CITY OF VAUGHAN

EXTRACT FROM COUNCIL MEETING MINUTES OF OCTOBER 21, 2020

2. RIZMI HOLDINGS LIMITED ZONING BY-LAW AMENDMENT FILE Z.18.004 DRAFT PLAN OF SUBDIVISION FILE 19T-18V004 11333 DUFFERIN STREET VICINITY OF DUFFERIN STREET AND KIRBY ROAD

DRAFT PLAN OF SUBDIVISION FILE 19T-18V004

Phase 1 Draft Plan of Subdivision File 19T-18V004 and Proposed Zoning including Park and Storm Water Management Pond

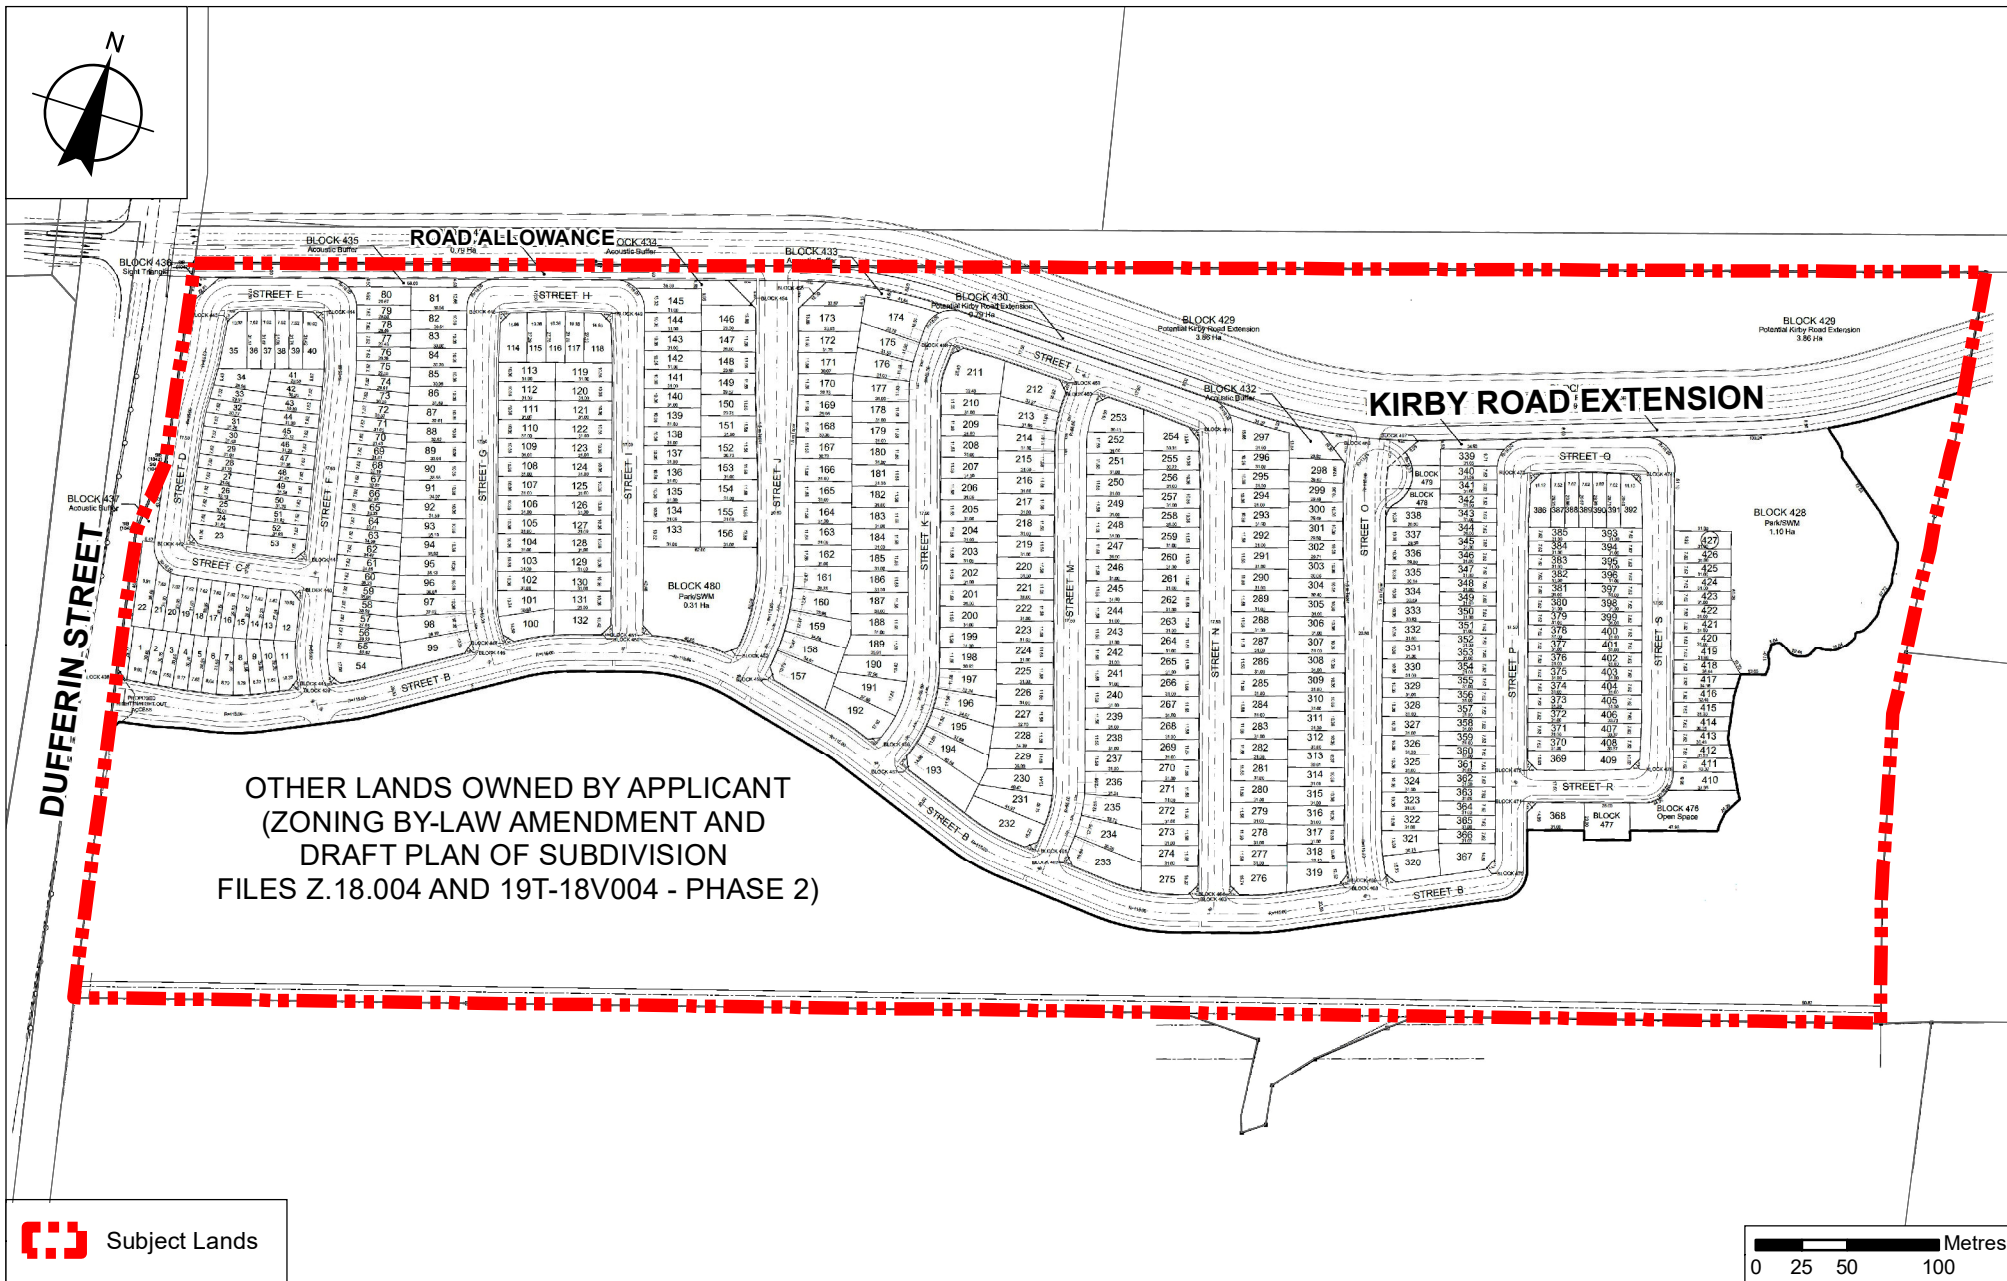
2. THAT the Holding Symbols '(H)', '(H1)', '(H2)', '(H3)', '(H4)', '(H5)', and '(H6)', as shown on Attachment 3, shall not be removed until the Owner provides the following to the satisfaction of the City of Vaughan Development Engineering Department:

3. THAT removal of the Holding Symbol '(H1)', as shown on Attachment 3, from the Subject Lands or any portion thereof, shall be contingent on the following:

- i. For Lots 157 to 158, 190 to 196, 229 to 234 and 274 to 275, the completion of the following materials and concurrence of the findings to the satisfaction of the City, in consultation with the Toronto and Region Conservation Authority:

- a. A Geotechnical/Slope Stability Study including a delineation of the toe of the wooded slope;
 - b. Plans to demonstrate how grading and retaining walls will be minimized to the greatest extent feasible; and

4. THAT the Holding Symbol '(H2)' and '(H3)', as shown on Attachment 3, shall not be removed from the Subject Lands or any portion thereof, until the following conditions are addressed to the satisfaction of the City:

- i. The Owner shall submit a finalized Stormwater Management Strategy;
 - ii. The Owner shall submit a Parks and Open Space Master Plan and Facility Fit Plan;

In accordance with this provision, the Development Planning Department recommends the portion of Block 421 designated as "Valley and Stream Corridor" by OPA 747 be zoned OS5(H) Open Space Environmental Protection Zone, with the Holding Symbol '(H)', as shown on Attachment 3.

The Draft Plan shown on Attachment 3 presents the interim conditions whereby unencumbered parkland measuring approximately 1.12 ha in size is provided on the east side of proposed Street 'O' (Park Block 338), located adjacent to a stormwater management block (3.23 ha – SWM Pond Block 339).

The Recommendations include conditions for a Draft Plan to permit either detached residential or open space park uses on the lots identified by the Owner in consultation with the Parks Planning Department on Attachment 3 (Block 338, approximately 1.12 ha). If the park identified in the eastern limits of the Draft Plan (Block 428) is not conveyed to the City due to the requirement for a stormwater management pond for the development of the Subject Lands, Block 338 on Attachment 3 (identified as Lots 328 to 357, Blocks 431, 478, 479 and Street P inclusive in the Draft Plan) for the purposes of a public neighbourhood park will be developed as a neighbourhood park and conveyed to the City as parkland. Should the approval of SWM under parkland be considered by the City, Block 428 will be conveyed and built by the Owner to the satisfaction of the City to coincide with the Phase containing the park or 25% occupancy of the approved residential lots.

Land Use Map for Minister's Order Superimposed on Draft Plan of Subdivision File 19T-18V004

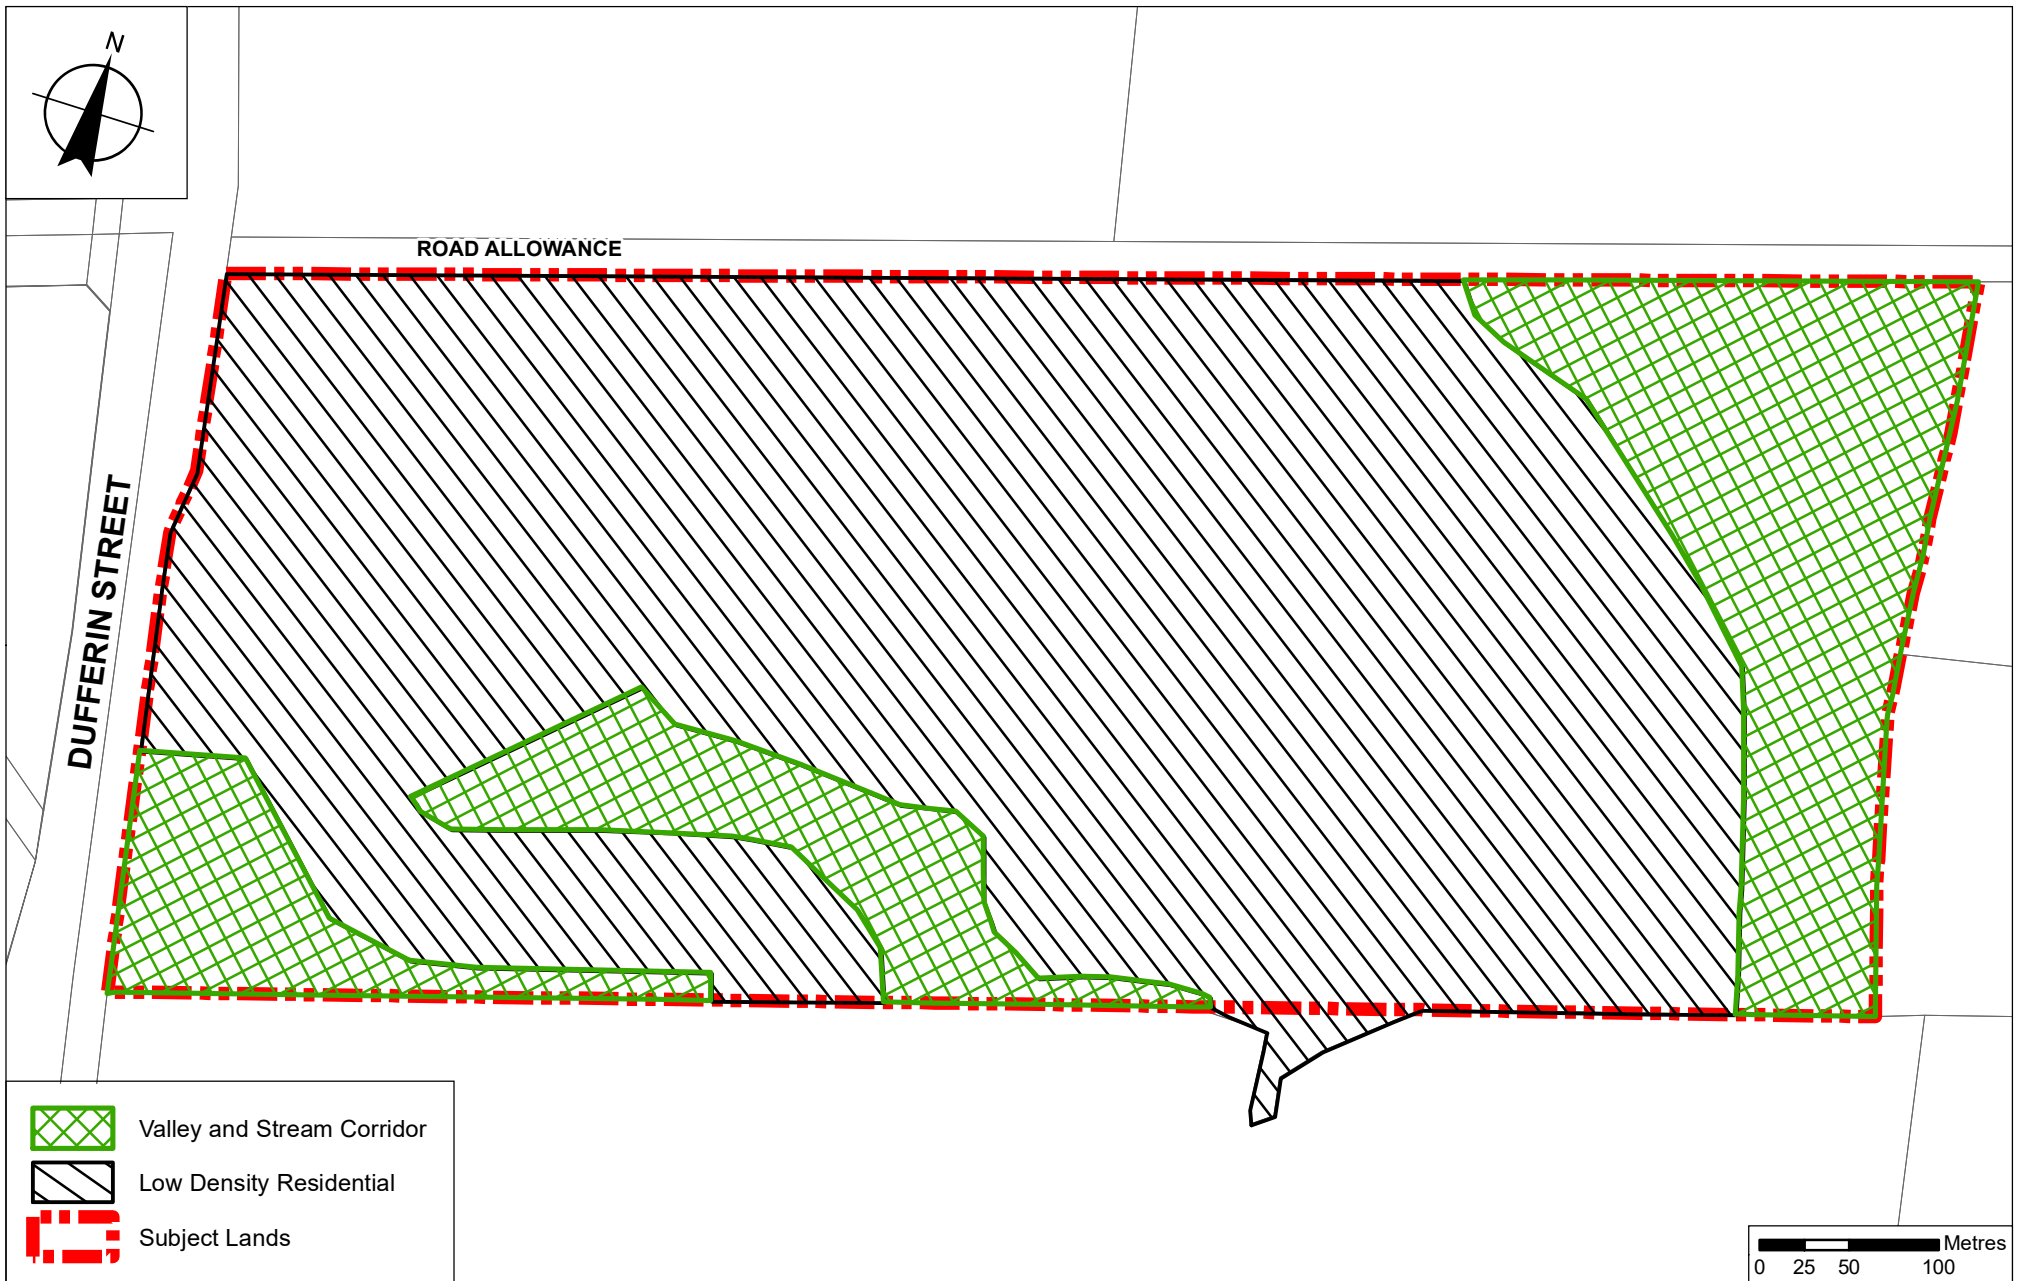
The Minister's Order, Schedule A to OPA 747 (Schedule F2 to OPA 600) identifies three areas designated Valley and Stream Corridor on the Subject Lands as shown on Attachment 6. In accordance with the Valley and Stream Corridor Policies of OPA 600, Section 5.9.1 provides for the protection of significant valley systems within the City of Vaughan. OPA 600 (Policy 5.9.1, 2) states the precise limits of valley and stream corridors will be established to the satisfaction of the City and Toronto and Region Conservation Authority ('TRCA') through the Block planning process based upon Policies 5.9.1, 2 i) to iv), as follows:

Valley and Stream Corridor, as it is associated with a surface water feature. The Toronto and Region Conservation Authority ('TRCA') requires the Owner to provide a continuous 10-meter environmental buffer, within Block 428 on the Plan, adjacent to the Valley and Stream Corridor designation as identified in OPA 747 in the eastern portion of the Subject Lands, in accordance with TRCA's requirements. A condition to this effect is included in Attachment 1c of this report.

As noted above, the EIS determined the two Valley and Stream Corridor designations in the southwest portion of the Draft Plan do not meet the definitions for Valley and Stream Corridors as identified in OPA 600. Most of these areas are not included in the Phase 1 Draft Plan and will be reviewed as part of Phase 2.

The Valley and Stream Corridor designation in the eastern portion of the Draft Plan meets the definition for Valley and Stream Corridor and is regulated by the TRCA. The TRCA has reviewed the Draft Plan and has provided Conditions of Approval included in Attachment 1c of this report.
